**CONTRA COSTA  
WATER DISTRICT**

**Subject: Draft Waste Discharge Requirements (WDRs) and Monitoring and Reporting Program (MRP) for the Grassland Bypass Project**

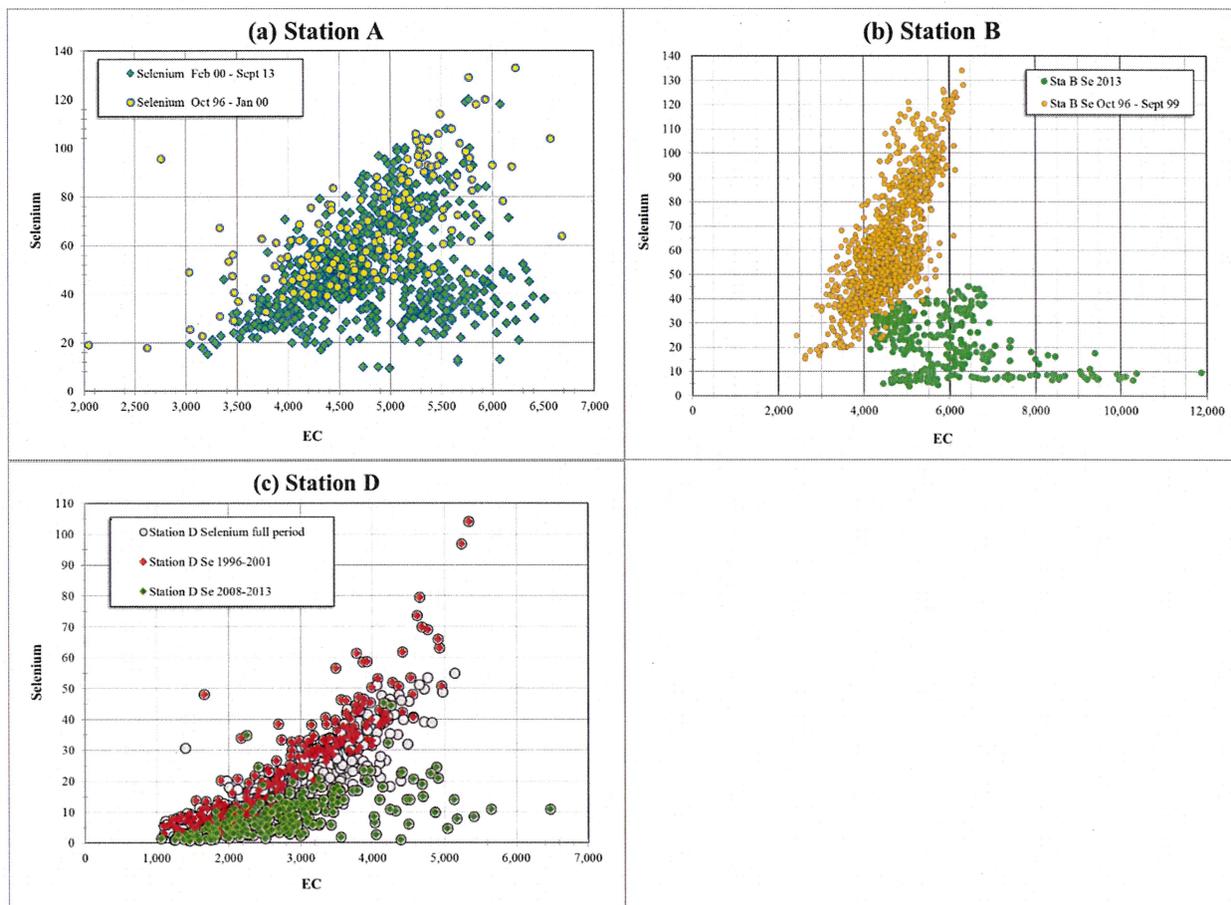
In addition, the draft WDR does not have the requirements for salt load values which were specified in Appendix E of the 2010 Use Agreement. The salt load limits specified in the 2010 Use Agreement are shown in Attachment 2. Although it was previously hoped that the reduction of selenium would also reduce the salt load from the Grassland Bypass Project, the selenium load limit itself is not sufficient to achieve the goal of salinity control. The relationship between selenium and salt concentrations has changed since the development of Grassland Bypass Project (please refer to Attachment 3 for details). CCWD requests that independent regulation of salt be included in the WDRs.

The monitoring data used for Figure 1 are from the portion of the San Luis Drain used by the Dischargers (Stations A and B) and in Mud Slough downstream of the Grassland Bypass Project (GBP) discharge (Station D). Figure 1 indicates that the relationship between selenium and specific electrical conductance (EC) has significantly changed since the start of GBP operations in 1996. Selenium concentrations have decreased much faster than EC (shown in Figure 2). This suggests that the significant reduction in selenium has not resulted in a corresponding reduction in salt and that independent regulation of salt is needed.
